<b>JRPP No.</b>	2009SYE012
<b>FILE No.</b>	DA 355/2009/1
<b>PROPOSAL:</b>	Partial demolition of the Synagogue, child care and ancillary buildings and the construction of a new Synagogue, new administration building with underground car parking for 14 (fourteen) vehicles, new ritual baths, new ancillary buildings, new child care centre for 60 (sixty) children, new security 'blast' walls and landscaping works
<b>APPLICANT:</b>	Indyk Architects Pty Ltd
<b>AUTHOR:</b>	Simon Taylor, Woollahra Municipal Council

## Assessment Report and Recommendation

<b>PROPERTY DETAILS</b>	7-9 Ocean Street, Woollahra (Temple Emanuel)
<b>Lot and DP No.</b>	Lots 1, 3 and 4 DP 189813 Lot 1 DP 206058 Lot 8 DP 18228
<b>Side of Street</b>	Eastern side of Ocean Street Western side of Woods Avenue Southern side of Kilminster Lane
<b>Site Area</b>	3,996.2m <sup>2</sup>
<b>Zoning</b>	Residential 2(a) Existing use rights apply
<b>TYPE OF CONSENT</b>	Local Development
<b>OWNER</b>	The Congregation Of The Temple Emanuel
<b>DATE LODGED</b>	14 July 2009 (Original submission) 9 February 2010 (Revised submission)

Existing view of Temple Emanuel from opposite side of Ocean Street

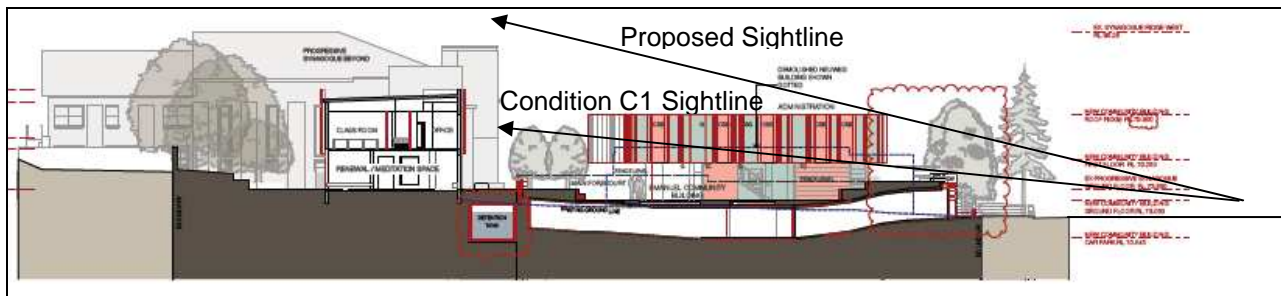
The Neuweg Synagogue can be seen on the left of the photograph. Its positioning alongside the northern boundary allows for an uninterrupted view (disregarding vegetation) to the entirety of the front façade of the Temple Emanuel for 66% of the street frontage. The view includes both levels of the building.

Front elevation of Administration/Community building (elevated above street level)

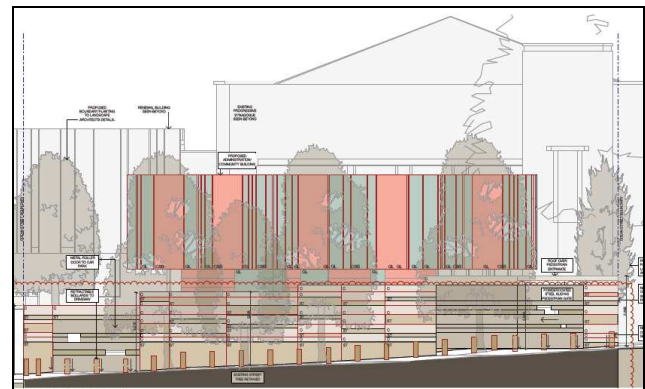
building will eliminate sightlines to the façade of the Temple Emanuel for all but 3% of the frontage. Furthermore, partial sightlines to a portion of the facade will only be from 15% of the street frontage.

Sightlines from the opposite side of Ocean Street over the proposed Community building

Sightlines will be limited to the southern corner

This stance would still be applied on streetscape planning grounds even if Amendment No. 66 was not gazetted in its current form. It is important to retain an open vista to the most prominent and significant building on the site, particularly given its location immediately opposite John Street.

Existing wall between 7 and 11 Ocean Street

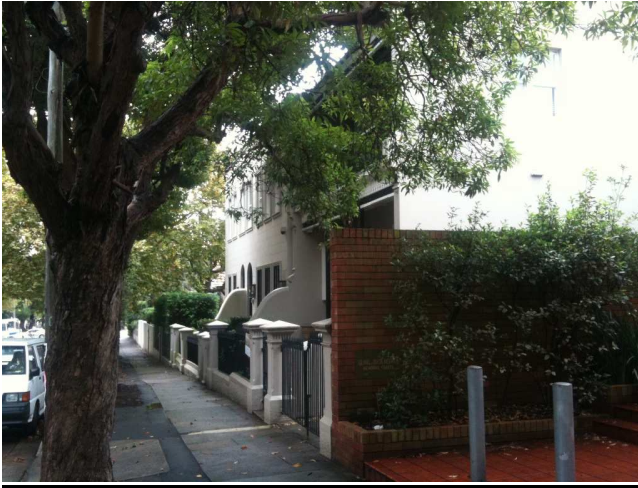
The height of the 'blast' security wall along the street frontage is up to 1.7m higher than is normally permissible in the Woollahra heritage conservation area. This would normally be undesirable. However, in certain instances, such as acting as an acoustic screen, a fence height in excess of 1.5m is deemed to be acceptable.

- The height of the fence is consistent with the height of the fence at 2A Ocean Street (diagonally opposite the subject site), as shown below
- The height of the fence is consistent with the height of the wall separation 7 and 11 Ocean Street, as shown below
